Safety Evaluation Report

related to the operation of
Palo Verde Nuclear Generating Station,
Units 1, 2, and 3

Docket Nos. STN 50-528, STN 50-529, and STN 50-530

December 1984

Figure 13.1 APS corporate organization

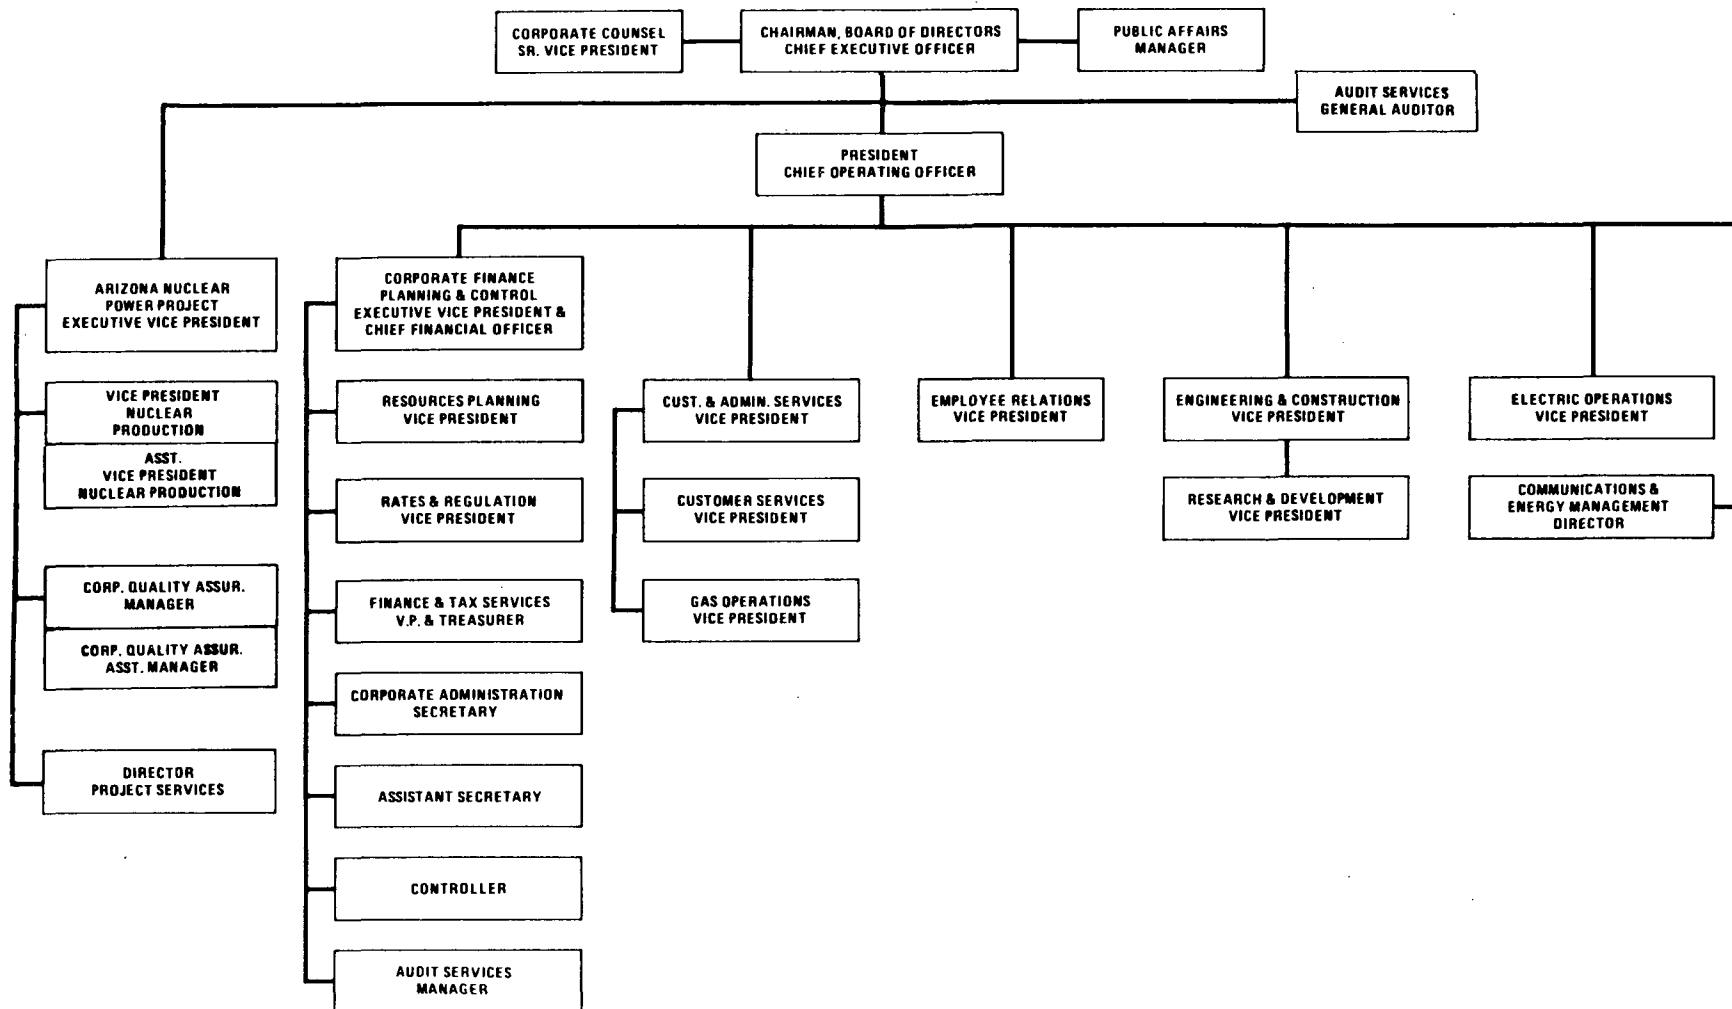
The applicant has implemented a number of changes in organizational structure since issuance of the PVNGS 1-3 SER in November 1981. Figures 13.1 through 13.3 in this section replace Figures 13.1 through 13.4 of the PVNGS 1-3 SER and reflect these organizational changes. This supplement addresses these changes as described through Amendment No. 13 to the Final Safety Analysis Report (FSAR) and considers the acceptability of the changes with respect to regulatory guidance. In addition, a number of individuals mentioned by name in the original SER no longer occupy the positions as specified at that time. The staff's review, however, indicates that the present incumbents of these positions satisfy the qualification requirements stated in ANSI/ANS Standard 3.1-1978, "Selection and Training of Nuclear Power Plant Personnel." For positions not covered by this standard, the staff's review indicates the qualifications of the present incumbents of these positions are appropriate to the responsibilities assigned and are acceptable.

The corporate structure of Arizona Public Service Co. (APS) has been significantly revised since the SER was issued (Nov. 1981). In the new organization (see Figure 13.1) overall responsibility and authority for the operation and technical support of Palo Verde Nuclear Generating Station, Units 1, 2, and 3 is vested in the Executive Vice President, Arizona Nuclear Power Project (ANPP). This individual reports directly to the Chief Executive Officer of the applicant's organization. The change in organization has also resulted in the consolidation of substantially all nuclear activities in the ANPP and the exclusion of substantially all non-nuclear activities.

Figure 13.2 APS nuclear organization

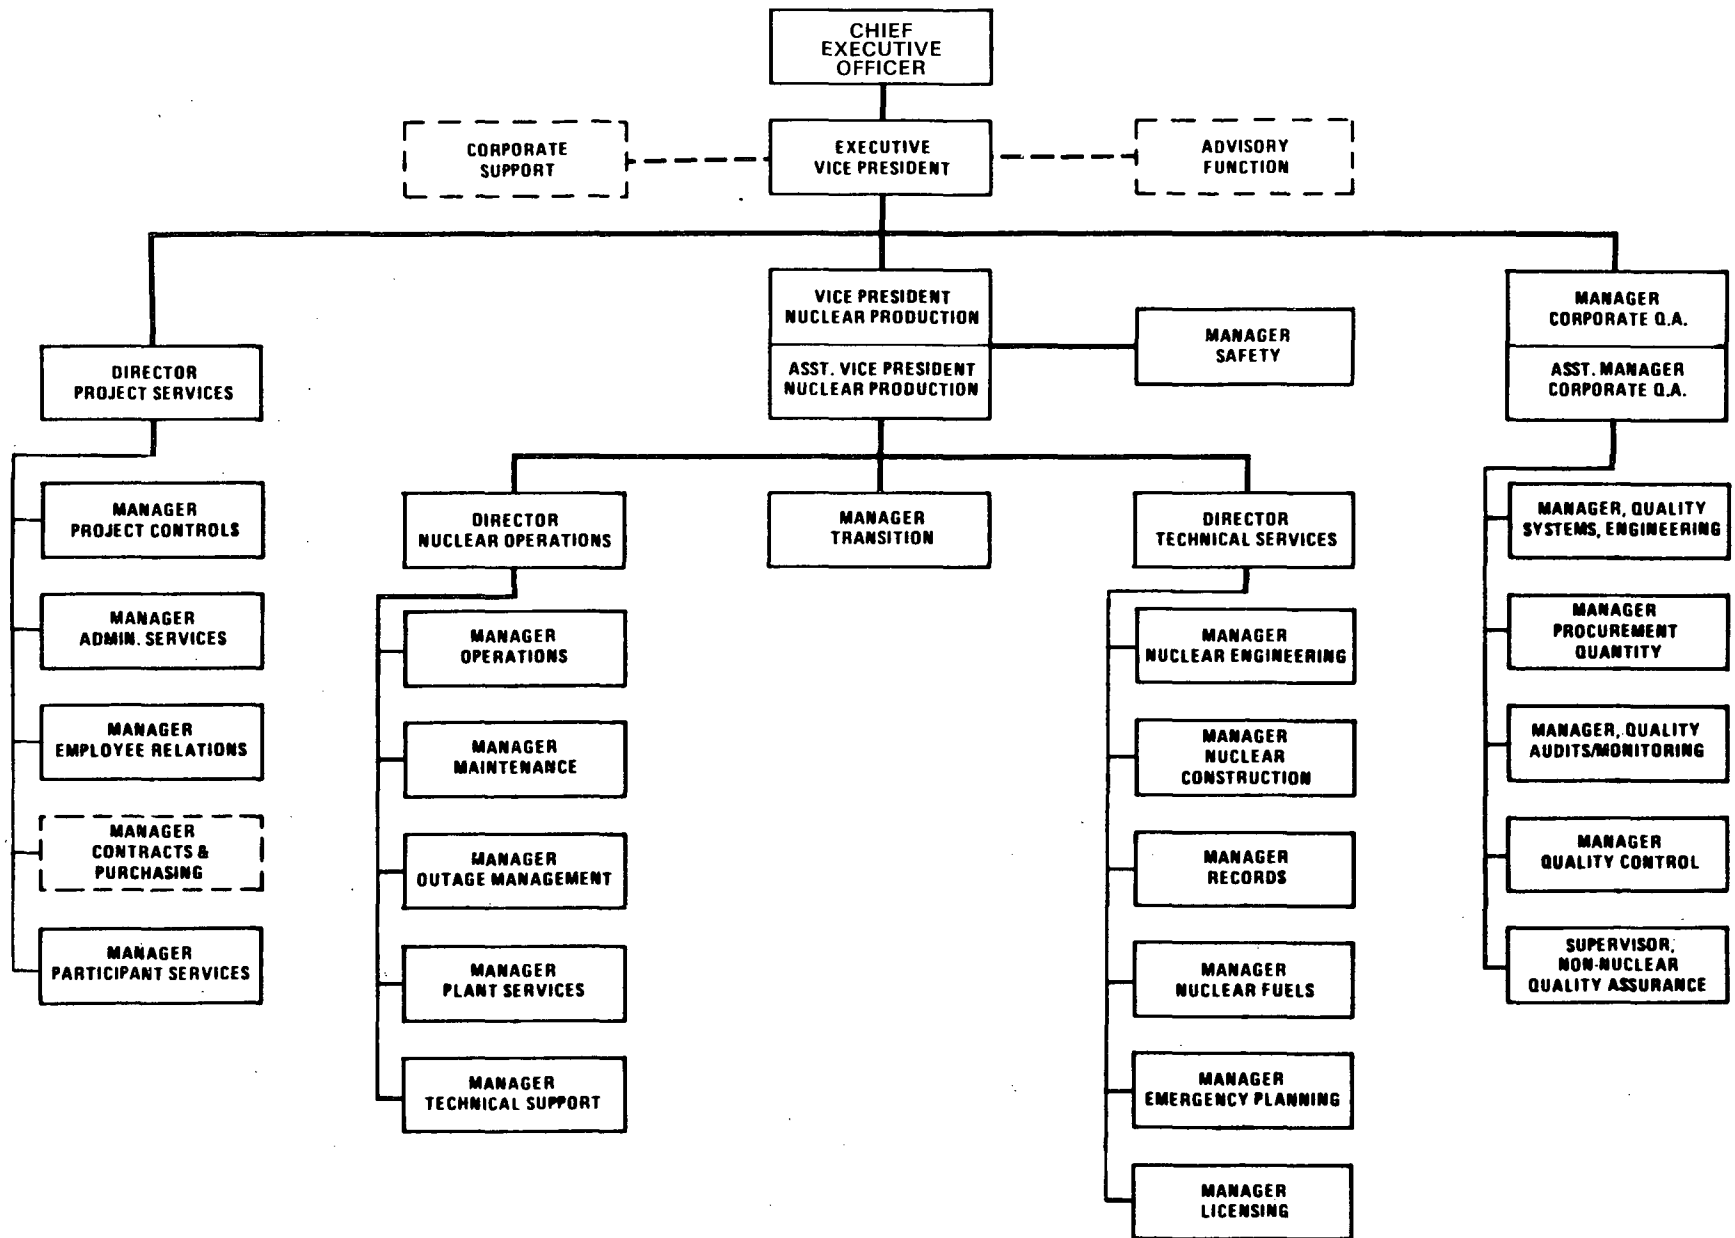
The organization of the Vice President, Nuclear Production, is shown in Figure 13.2. Although the new organization imposes significant construction and operations responsibilities on a single individual (the Vice President, Nuclear Production), the applicant has taken steps to address this matter. These include removing some administrative and technical duties, and appointing an Assistant Vice President, as noted above.

As shown in Figure 13.2, other positions reporting to the Vice President, Nuclear Production, are the Director of Nuclear Operations, the Director of Technical Services, the Transition Manager, and the Nuclear Safety Manager. The functions reporting to the Directors of Nuclear Operations and Technical Services, are also shown in Figure 13.2.

Figure 14.1 Control element assembly extension shaft guides

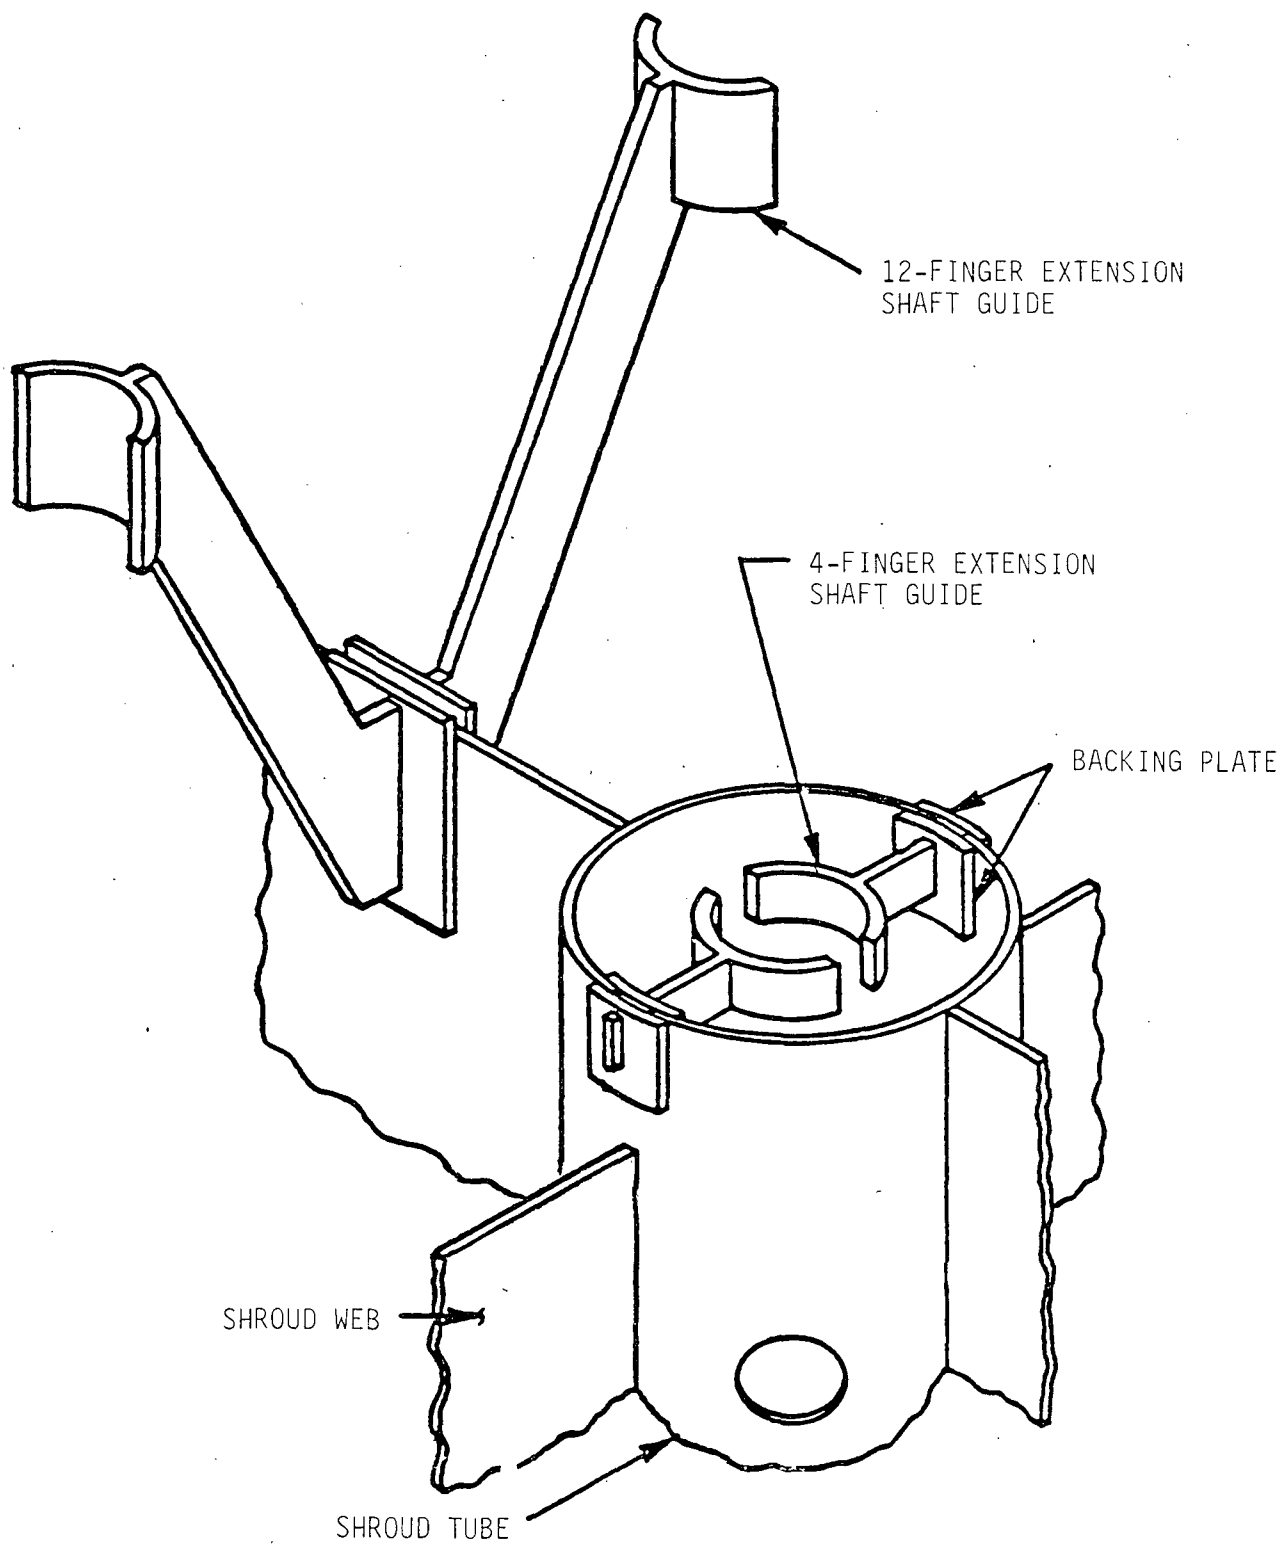
Inspection of the PVNGS Unit 1 reactor internals subsequent to HFT in July 1983 revealed damage to the control element assembly shroud (CEA shroud). The CEA shroud is part of the upper guide structure (UGS) assembly. It consists of an array of vertical round tubes (9-in. OD) which are arranged in a square grid pattern with 16-in. pitch. The tubes are joined by welding vertical plates called webs between adjacent tubes, as shown on Figure 14.1. Tubes and webs are made from 3/16-in. type 304 stainless steel. The purpose of the CEA shroud is to provide separation of the CEAs. The CEA shroud is mounted on eight pads on the UGS base plate and is held in position by eight tie rods which are threaded into the UGS base plate at their lower end. At their upper end, the pretensioned tie rods are held by nuts which bear on eight plugs in the tops of eight of the CEA shroud tubes. Guides for the 4-finger CEA extension shafts are attached to the top of the tubes, and guides for the 12-finger CEA extension shafts are attached to the webs. These guides serve the purpose of aligning CEA extension shafts for entry into the closure head nozzles during closure head installation and into the internals lift rig during attachment.

The structures were modified to eliminate the potential resonance failure caused by vibration of the CEA 4-finger and 12-finger guides and to eliminate the locations of the original failures. In addition, to eliminate the possibility of future transgranular stress corrosion cracking, the shielded metal arc weld process was not used in the modified design for fillet, double fillet, or partial penetration. The staff also reviewed fabrication documentation for the modified PVNGS Unit 1 shroud to ensure that such welding was not used.

On the basis of a review of the applicant's analyses, in conjunction with the hydraulic tests, mechanical vibration tests, and full-scale demonstration test at PVNGS Unit 1, the staff concludes that the original causes of the cracks have been effectively removed and that the modified CEA shroud design is acceptable for long-term operation.

Figure 17.1 Arizona Public Service Company organization for PVNGS operation

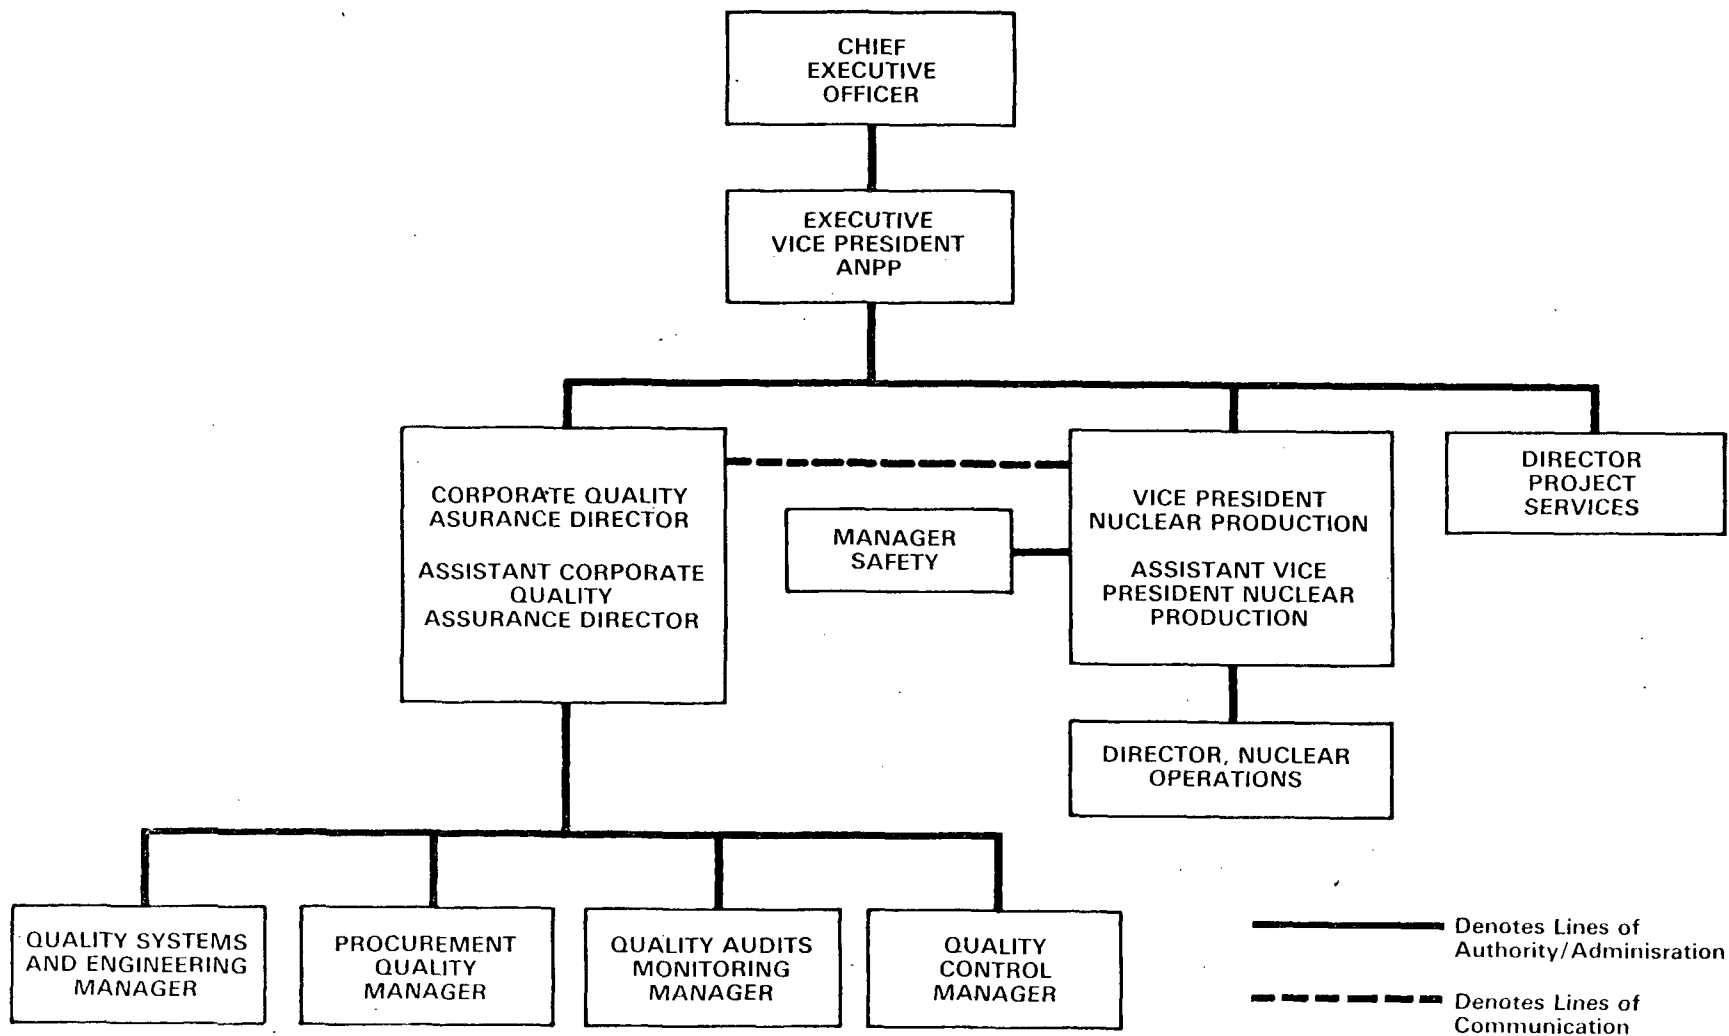
The structure of the organization responsible for the operation of PVNGS 1-3 and the establishment and execution of the operations phase quality assurance program is shown in Figure 17.1 of this supplement. The Arizona Nuclear Power Project Executive Vice President is responsible to the Chairman of the Board and Chief Executive Officer of the Arizona Public Service Company for promulgating the quality assurance program requirements. He has ultimate responsibility for quality assurance of PVNGS 1-3. The Vice President, Nuclear Production; the Director, Project Services; and the Corporate Quality Assurance Director each report to the Arizona Nuclear Power Project Executive Vice President.
